# **Bell Helicopter** **TEXTRON**

**SUBJECT: REVISION "A" TO TECHNICAL BULLETIN 407-99-19,  
ENGINE OIL SYSTEM FLEXIBLE HOSES 70-  
079K000Z232 AND 70-061J000V204A, INTRODUCTION  
OF.**

**NO** 407-99-19

**SUBJECT:** **ENGINE OIL SYSTEM FLEXIBLE HOSES  
70-079K000Z232 AND 70-061J000V204A,  
INTRODUCTION OF.**

Figure 1. Flexible Oil Hoses and Union – Installation (Sheet 1)

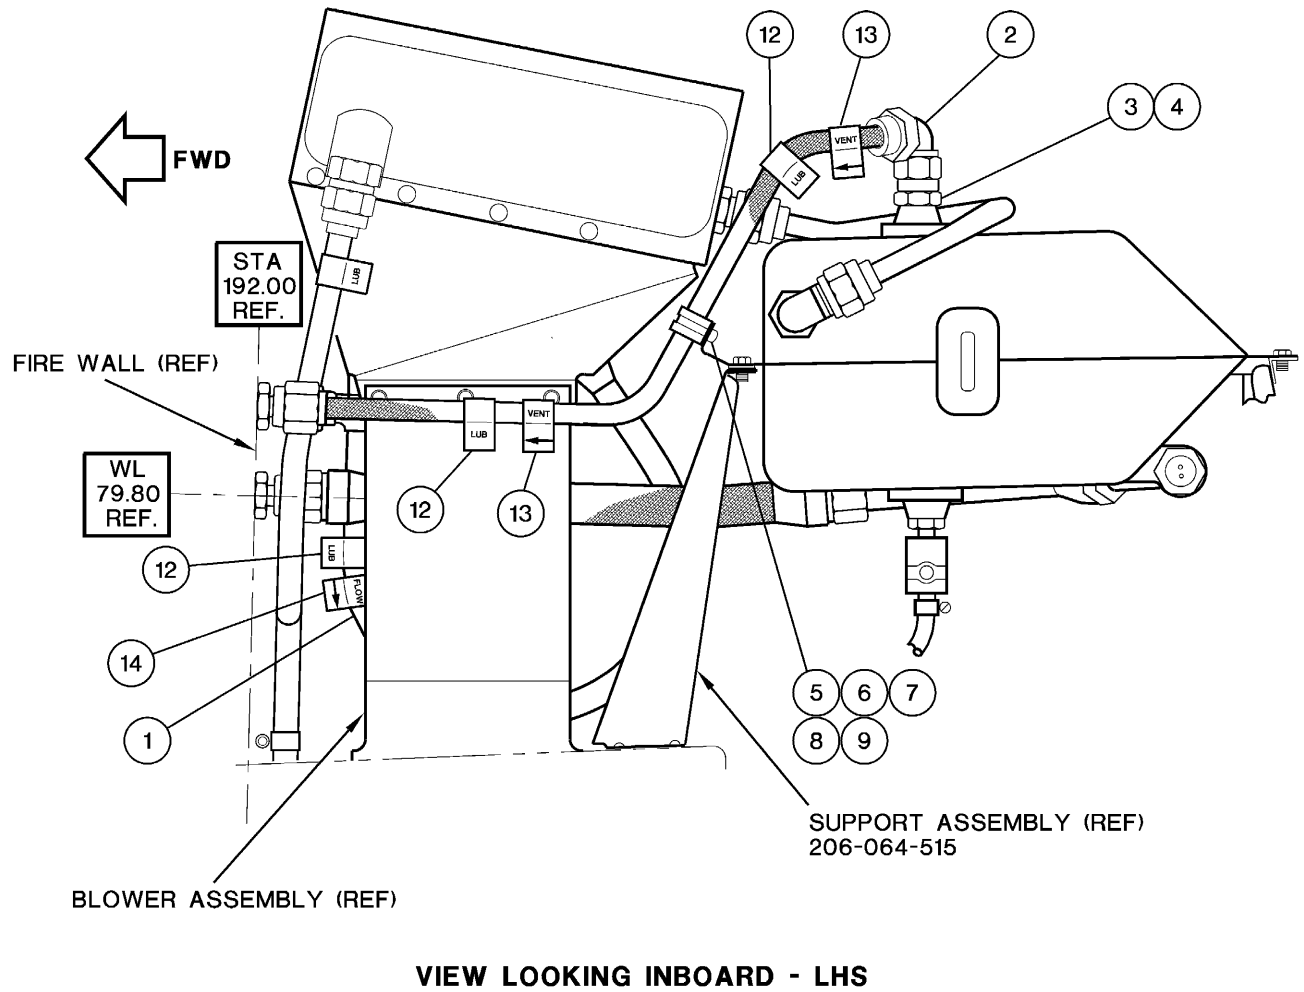
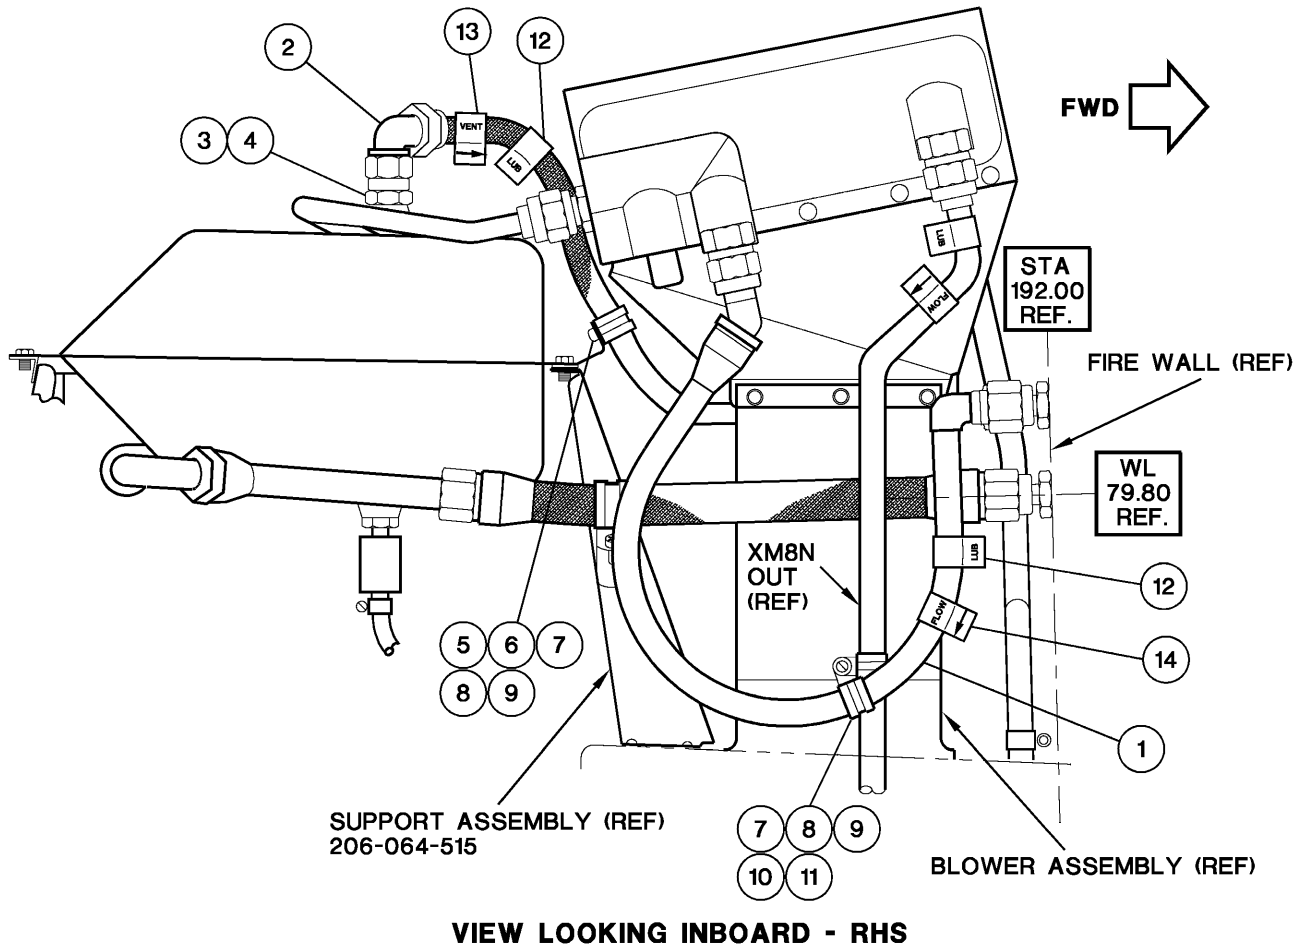
Bell Helicopter has found that cracks on the aft engine firewall can be caused by vibration transmitted by the rigid oil tubes 407-062-659-101 and 407-062-523-101. This bulletin introduces two new flexible oil lines, 70-079K000Z232 and 70-061J000V204A, to replace the installed rigid oil tubes and isolate this vibration.

5. Install the packing (4) and union (3).
6. Use bracket (5, Figure 1), clamp (6), screw (7), nut (8), and washer (9) to install the oil tank vent flexible hose (2).

7. Use the screw (7), nut (8), washer (9), and clamps (10 and 11) to install the engine oil-return flexible-hose (1).
8. Install the line identification tape decals (12, 13, and 14).
